PLANNING BOARD

Topic: Planning Board Workshop and Public Hearing 1-24-2023

o: Chair Stanley & Members of the Planning Board
From: Maya Balassa
Date: January 17th, 2023
Re: 180 Read Street Major Site Plan
Project ID: PL-002223-2022
CBL: 147 B001001
Meeting Date: January 24th, 2023

C-30

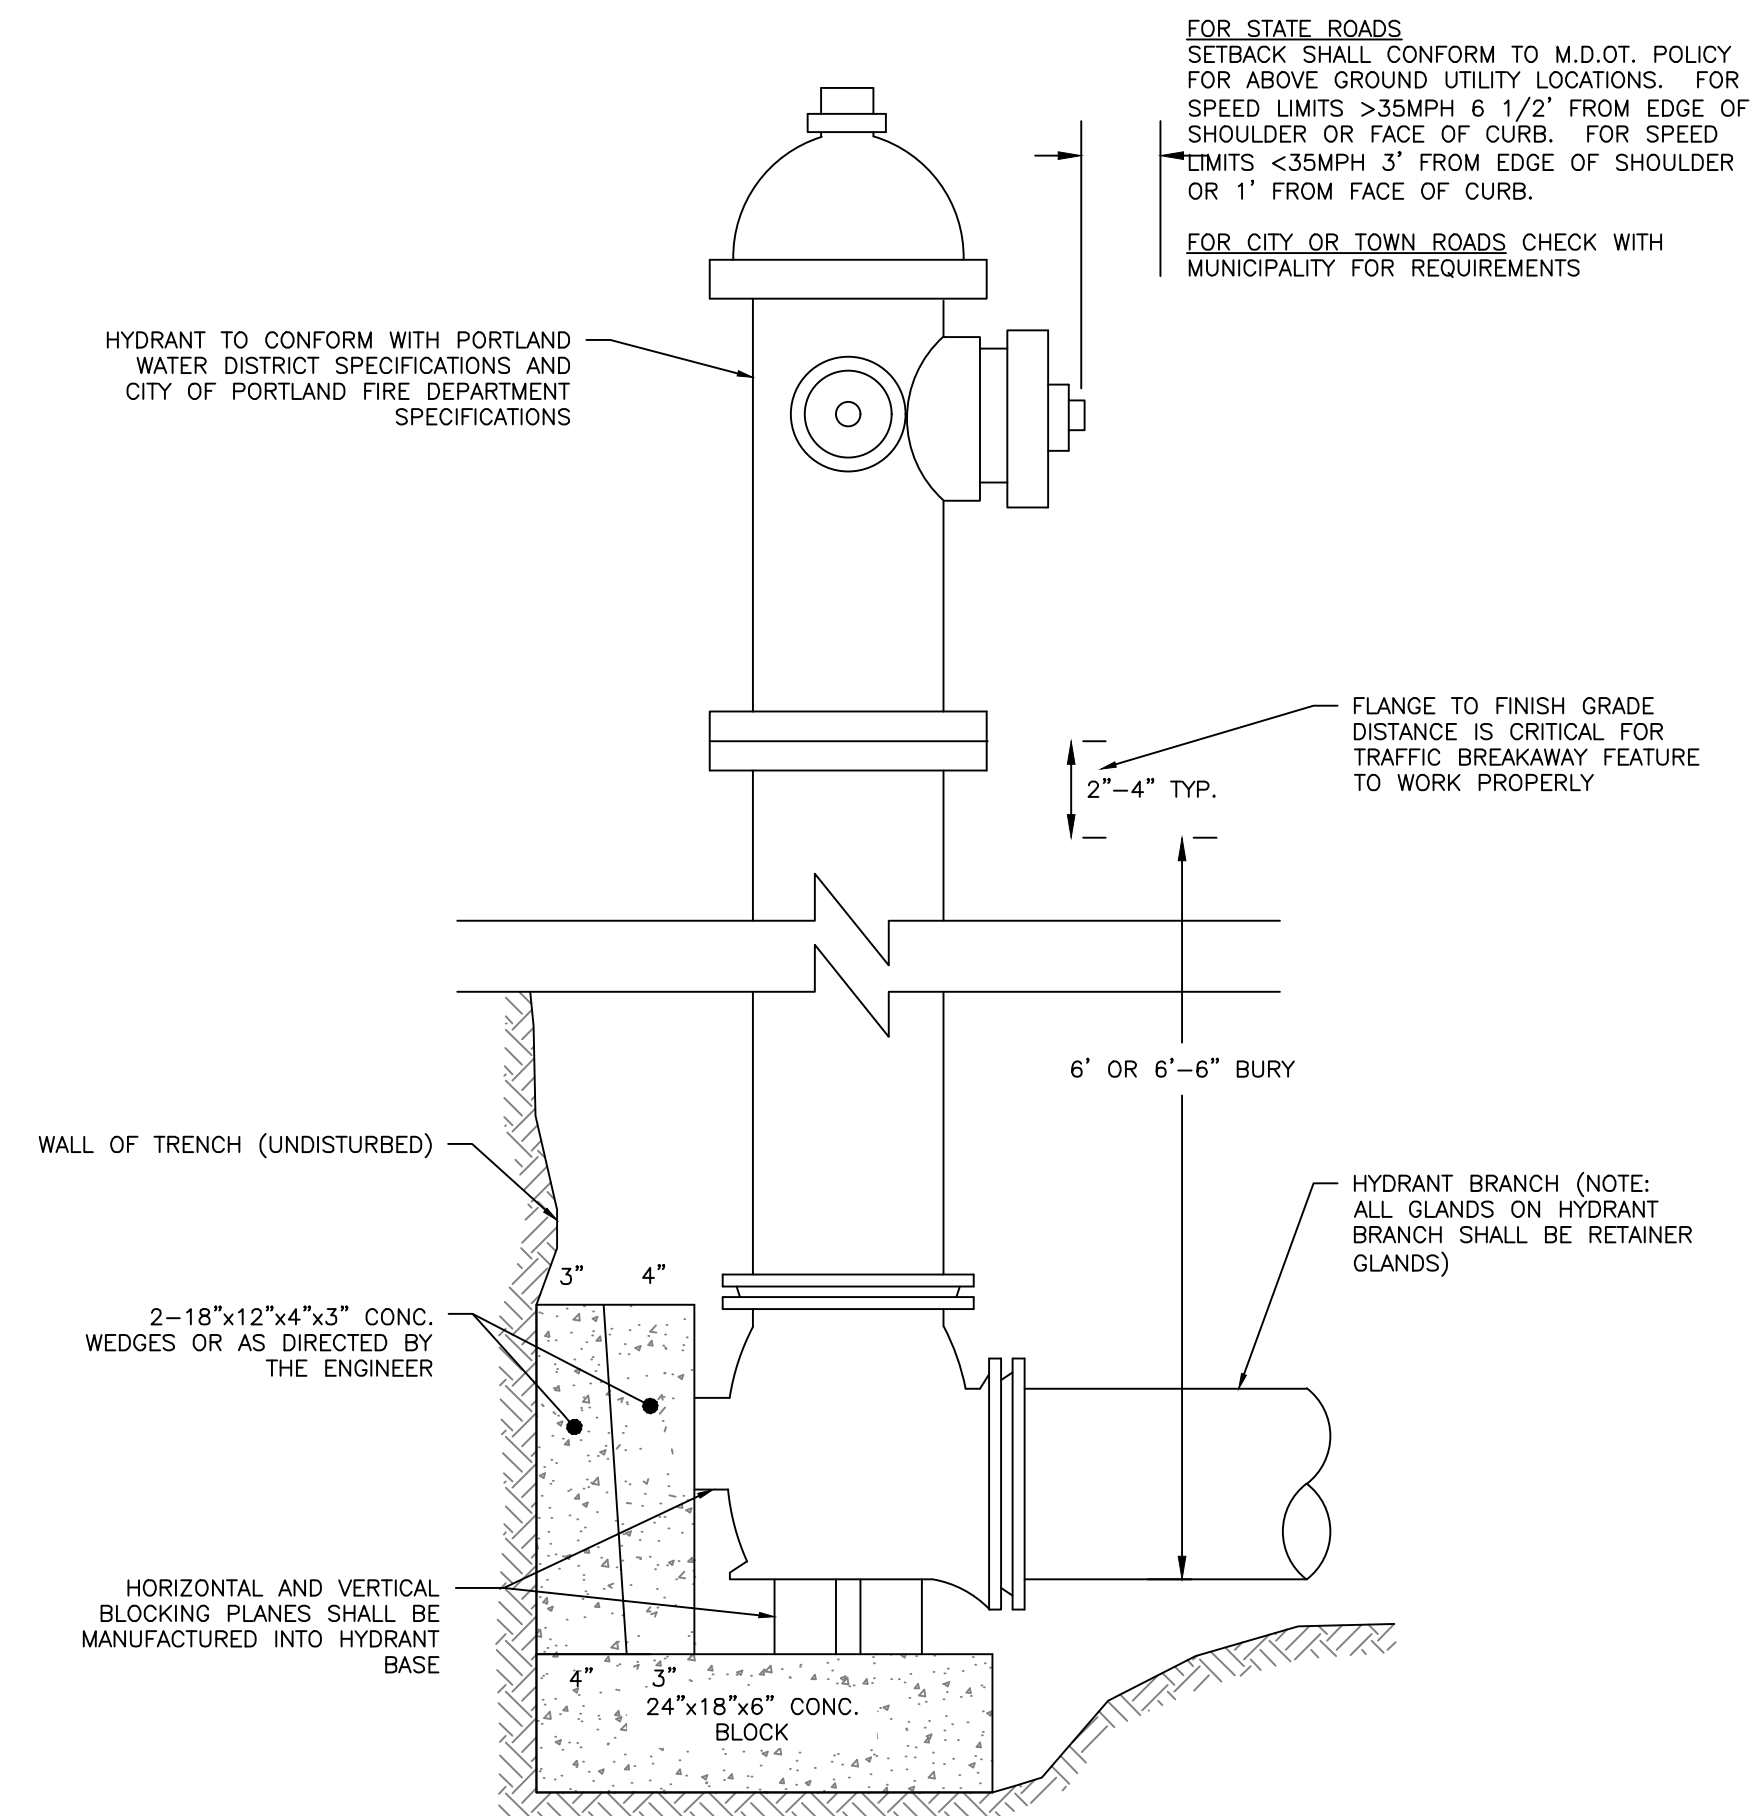
Response – This crossing of pipes was in error, thank you. The invert of the roof drain at the building has been raised to give clearance over the top of the sewer lateral. The sewer manhole and lateral have also been added to Sheet C-30 for clarity.

C102

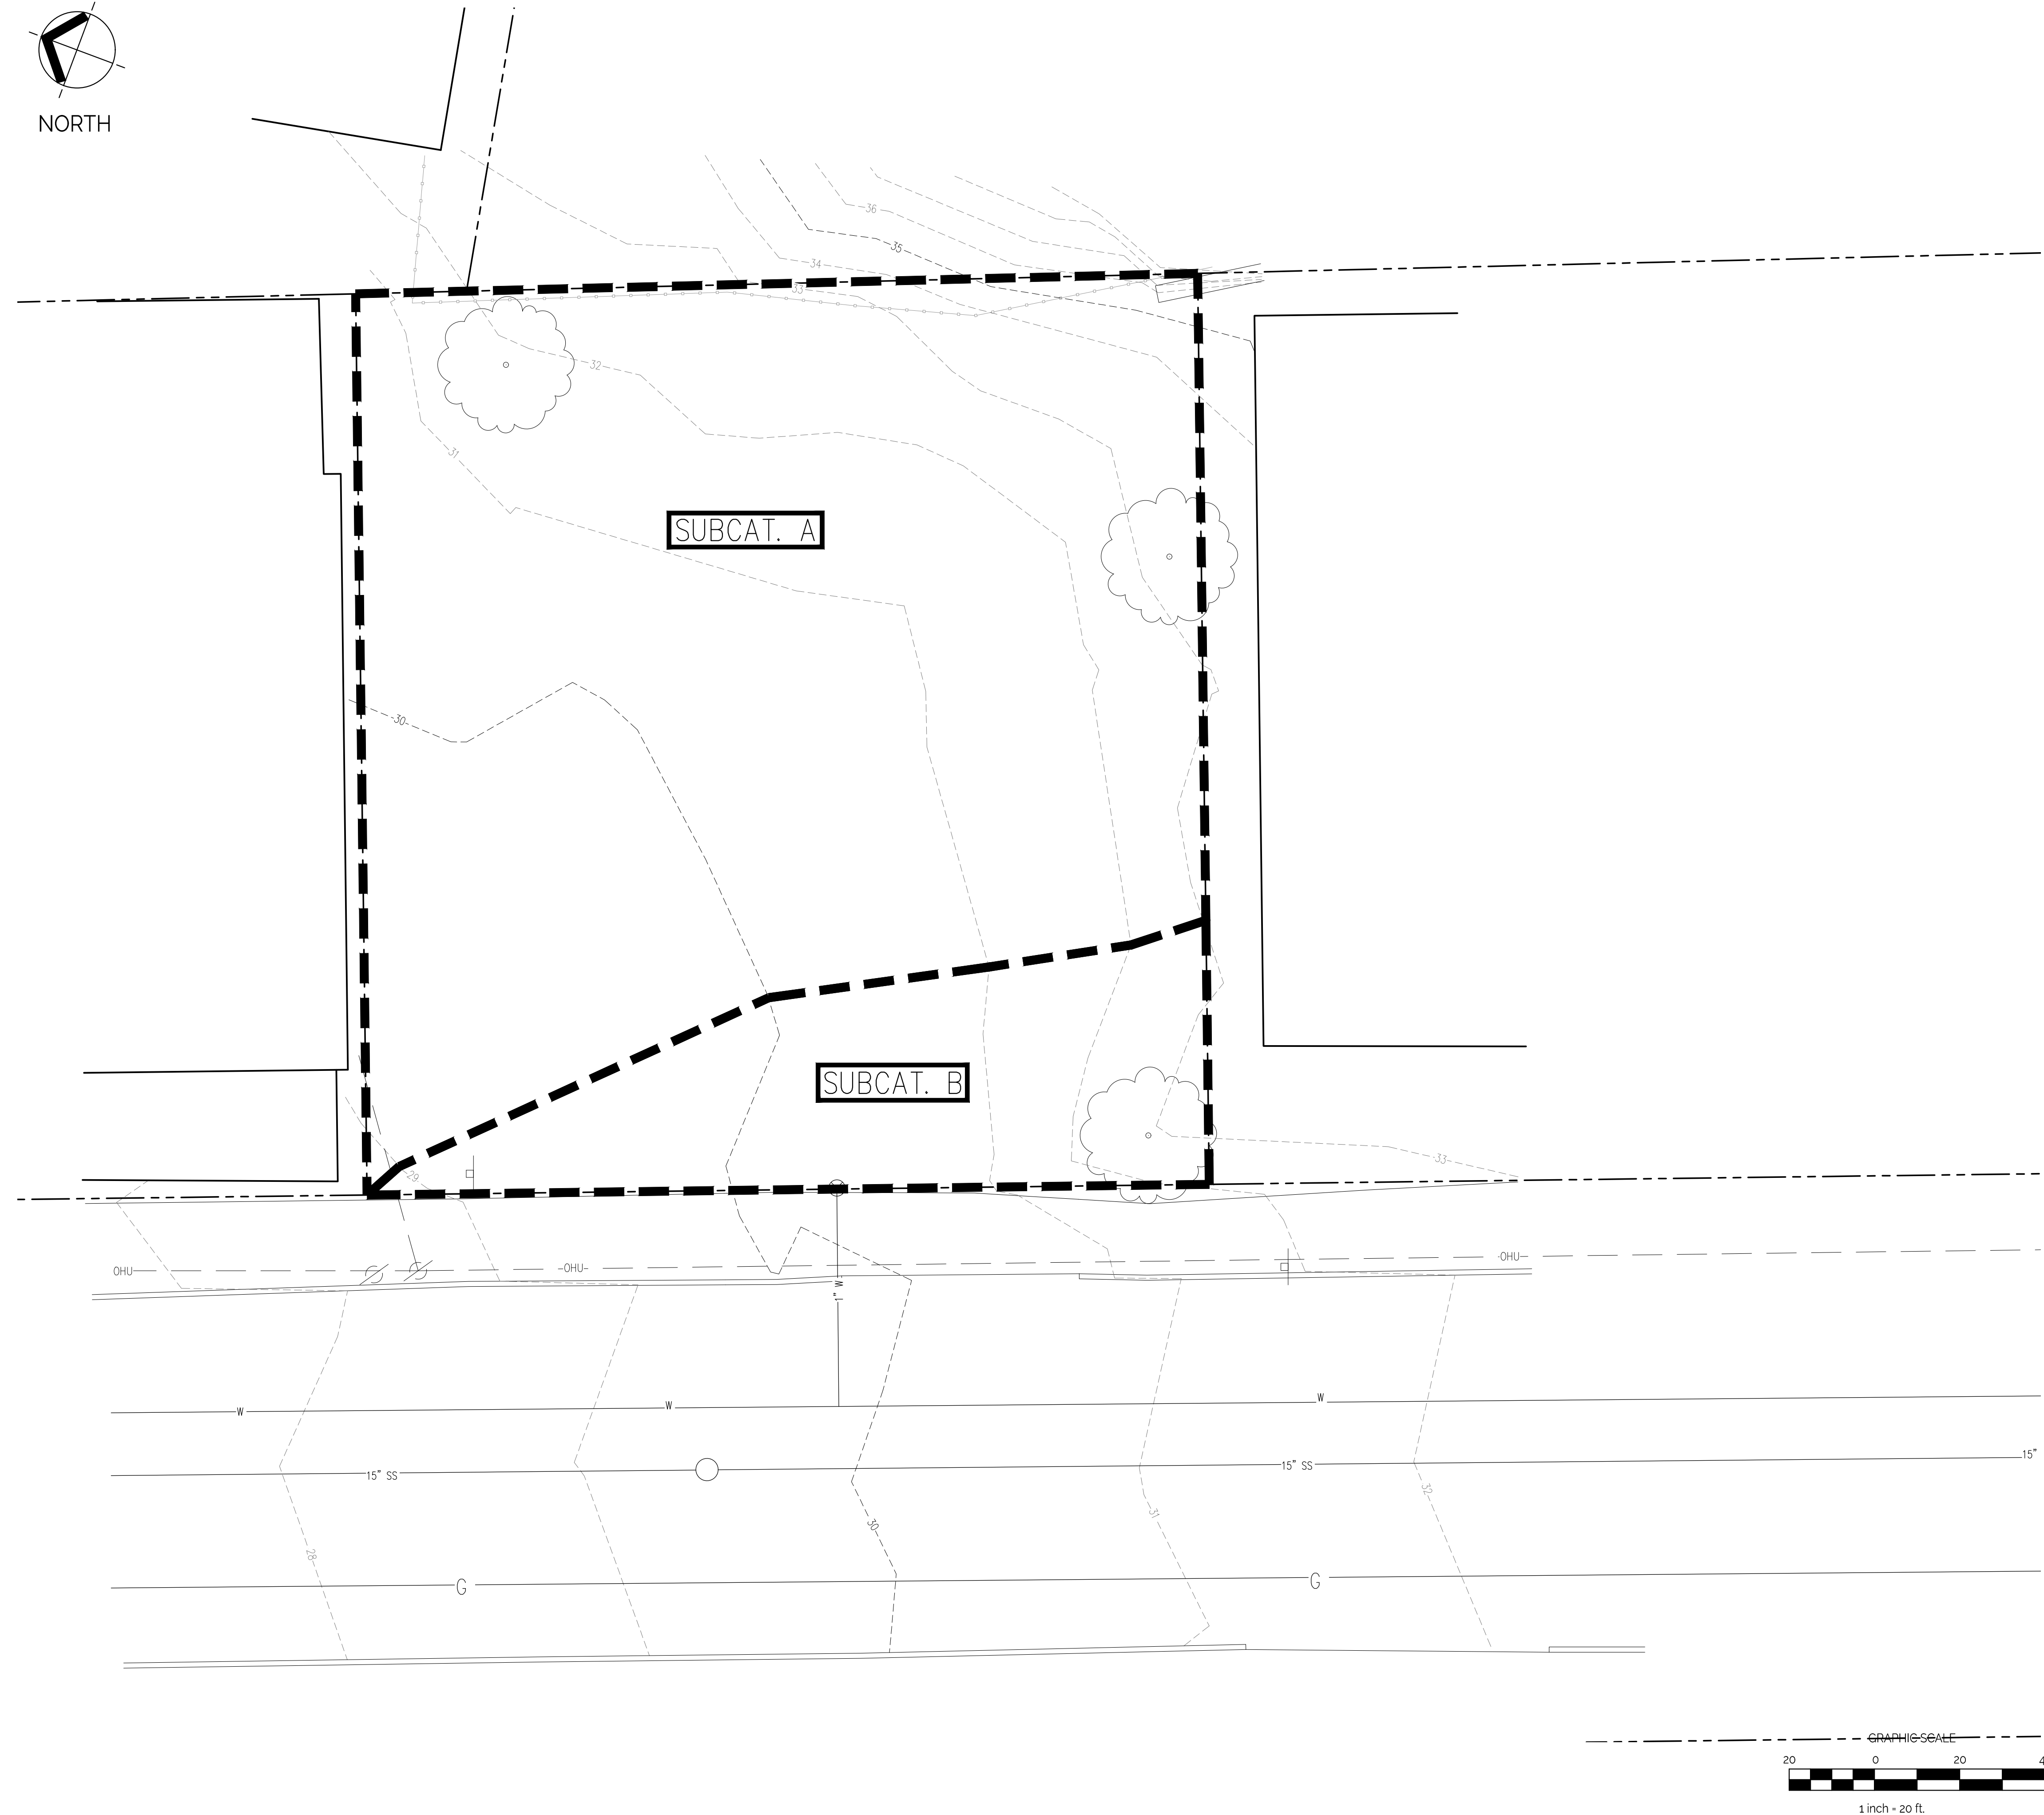
- It appears the grading on sheet C-101 has been updated to direct offsite runoff towards the proposed rain garden system. Sheet C-101 should be updated to show the location and rim elevation of the proposed beehive overflow, and the location and elevation of under drain piping. The applicant has set the top of the rain garden at elevation 30.50. The overflow structure rim in the rain garden is set at 30.20. The applicant should clarify how runoff will be directed towards the street and not neighboring property in the event that the overflow gets overwhelmed or plugged. It also doesn't appear the applicant has submitted updated stormwater management calculations to account for the additional offsite watershed area being directed to the rain garden. *Grading has been revised on drawing C101 to ensure that stormwater is directed to the proposed raingarden. I added in a lower spot grade depression on the streetside of the proposed raingarden for an emergency overflow if the beehive grate is plugged during a storm event.*

C104

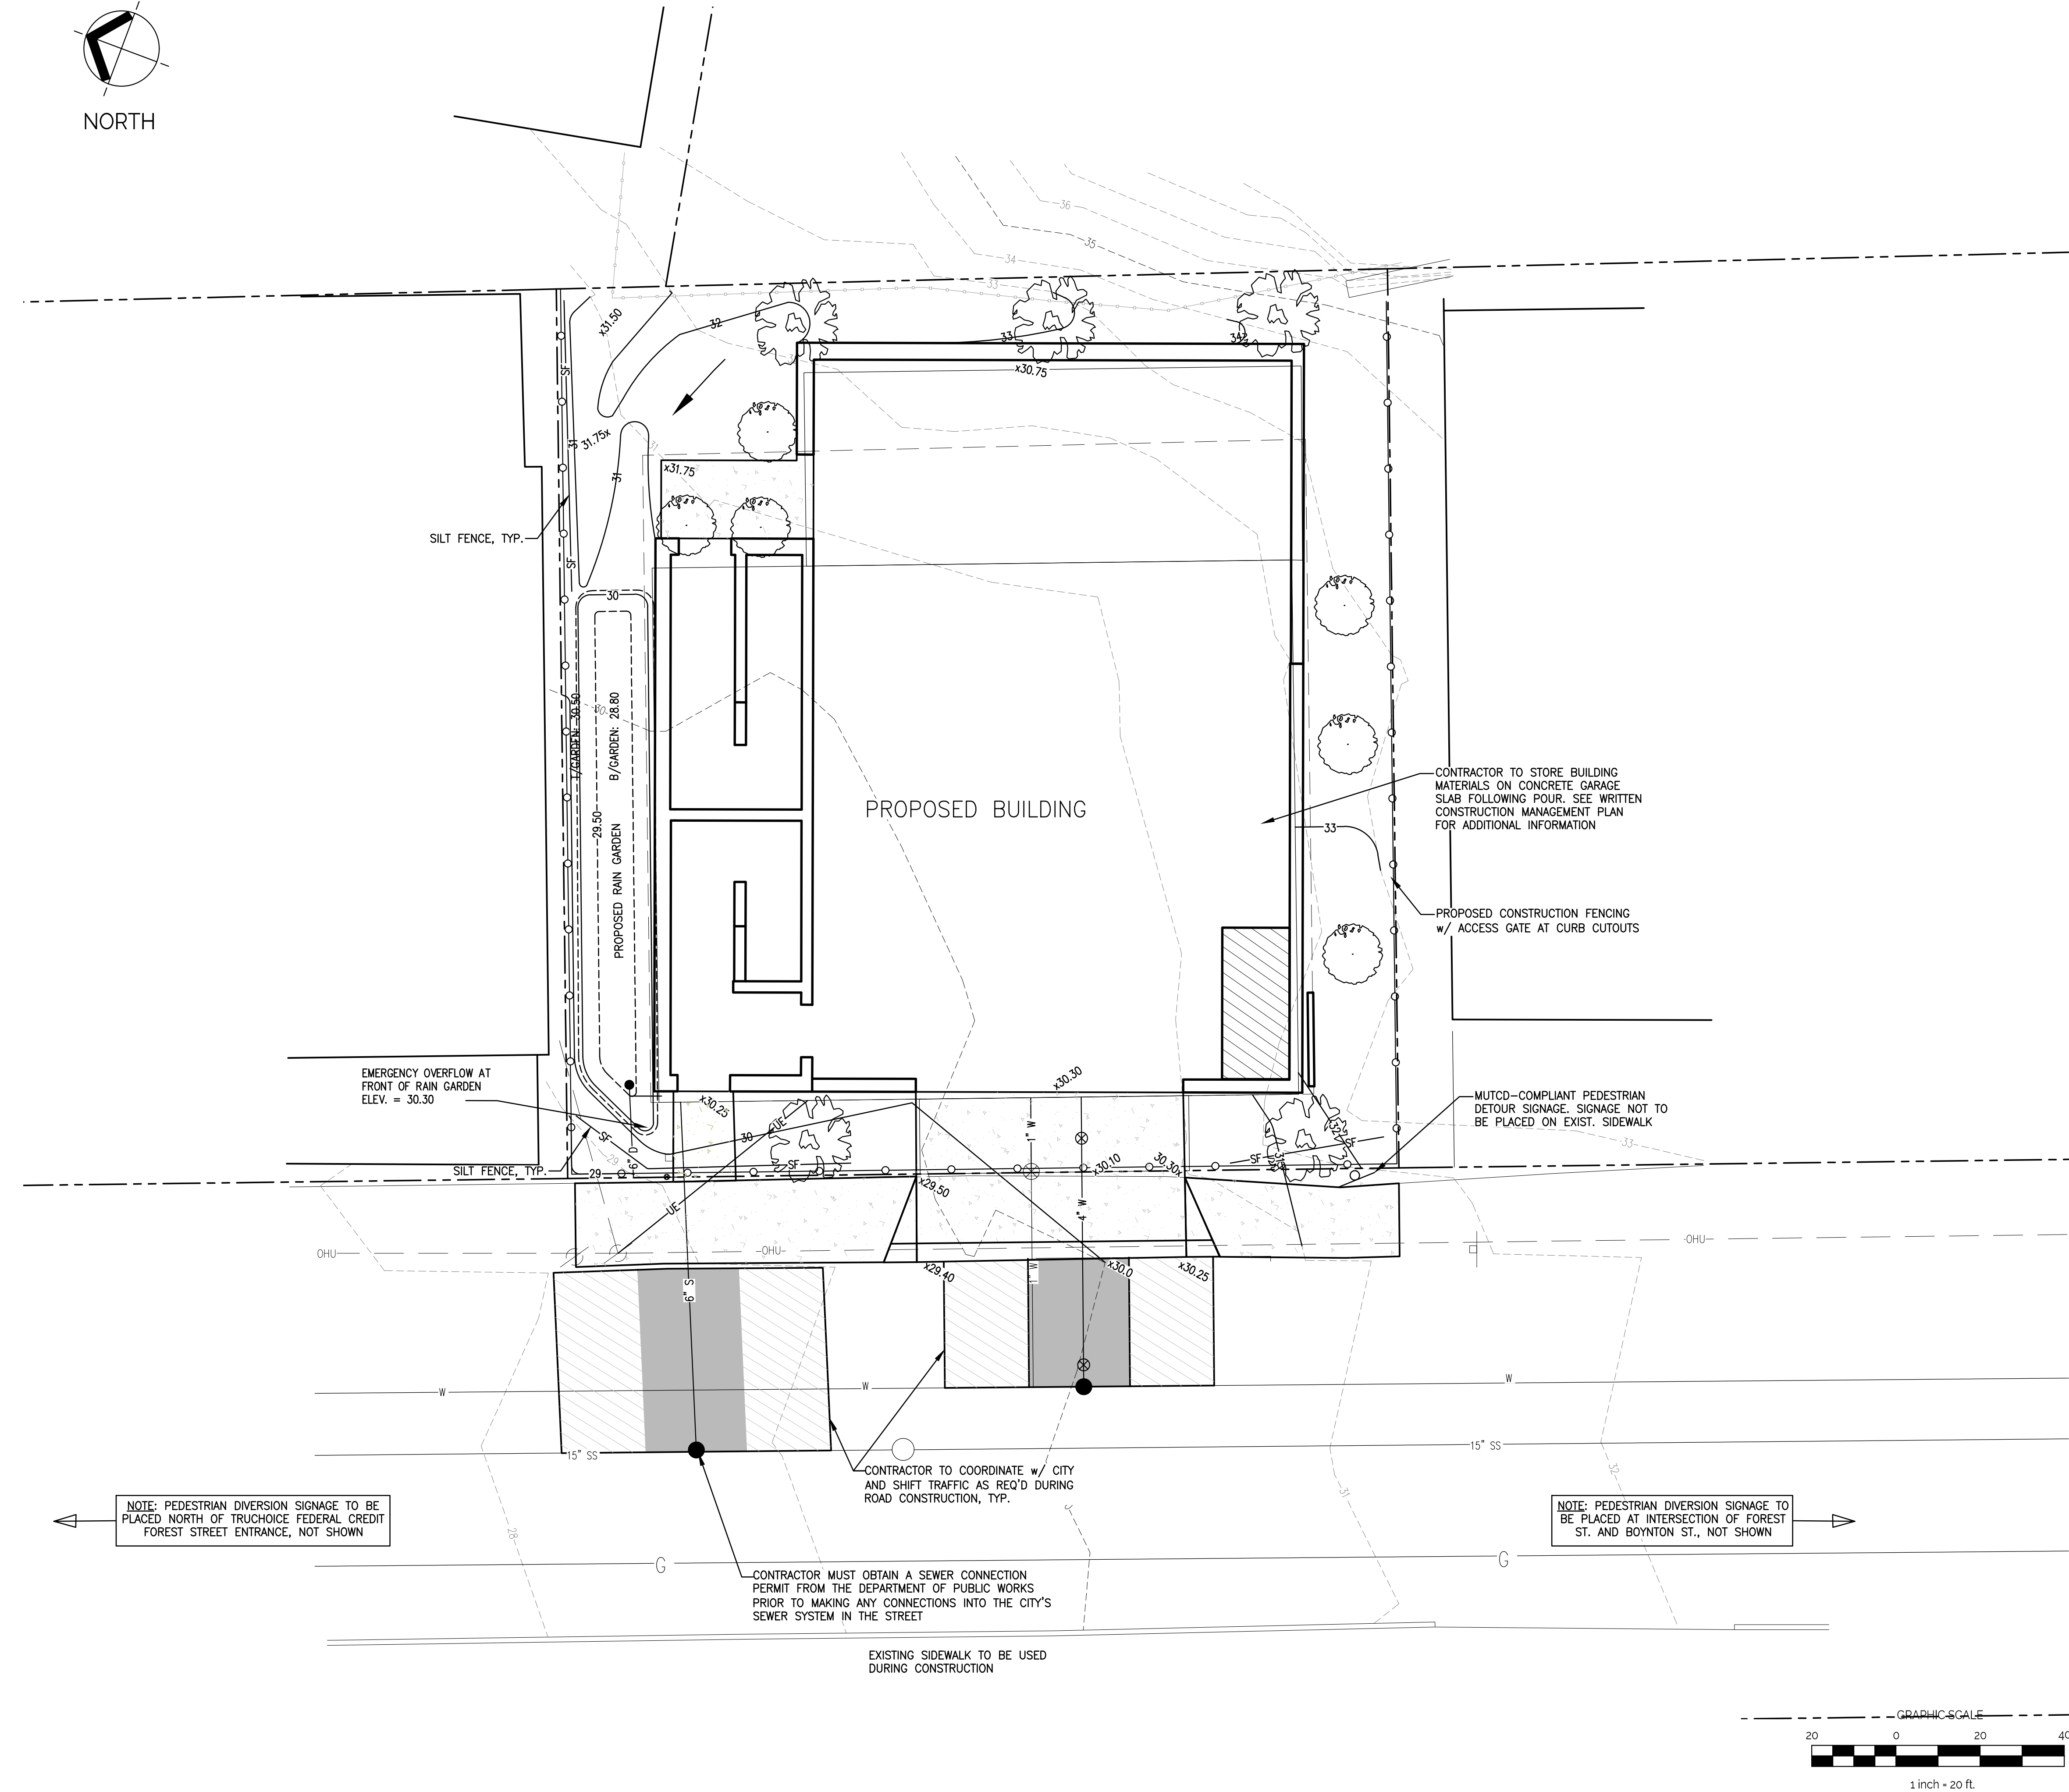
- Sheet C-104 should be updated to depict the grading updates made to C-101 in this latest submission. *C104 has been revised as requested*
